Amendment 2 of 2 to the ITB: Supply of Armoured Doors

RFQ Reference No.: 90801_ITB_CAR_Armoured Doors_15_04

Date: January 29th, 2015

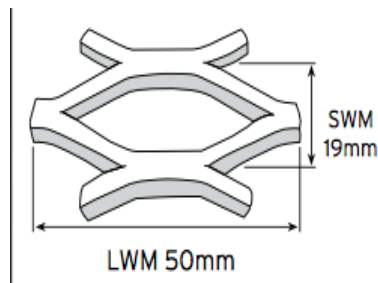
Page 15, Annex C, Technical Specification (Excel Sheet)	
THE FOLLOWING:	IS HEREBY AMENDED TO:
Armoured door fabricated with 6mm outer plate	Armoured door fabricated with 6mm steel plate, reference picture see Annex A
Wall Opening of 1935mm x 830mm	Wall Opening of 1935mm x 830mm
Clear opening 1870 x 750mm (door opening 180°)	Clear opening 1870 x 750mm (door opening 180°)
4 bolts, 4 dog bolts	8 bolts (40mm diameter) 4 front side and 4 back side
7 lever key lock	7 lever key lock, incl 3 copies of the key
20mm overlap on door	No longer Required
door frame included	Full steel door frame included
Fabricated with internal issue gate door	Fabricated with internal issue gate door (lockable)
sliding bolt to lock with 50mm expanded steel mesh frontage	sliding bolt to lock with 50mm expanded steel mesh frontage, mesh specification see graphic Annex B
Non-deteriorating insulation material	Non-deteriorating insulation material

Rustproof undercoat for final painting	Rustproof undercoat for final painting
Weight must not exceed 240kg	Weight must not exceed 240kg
Must offer excellent protection against fire and skilled methods of attack	Please include product brochures, certificates and test results if existing
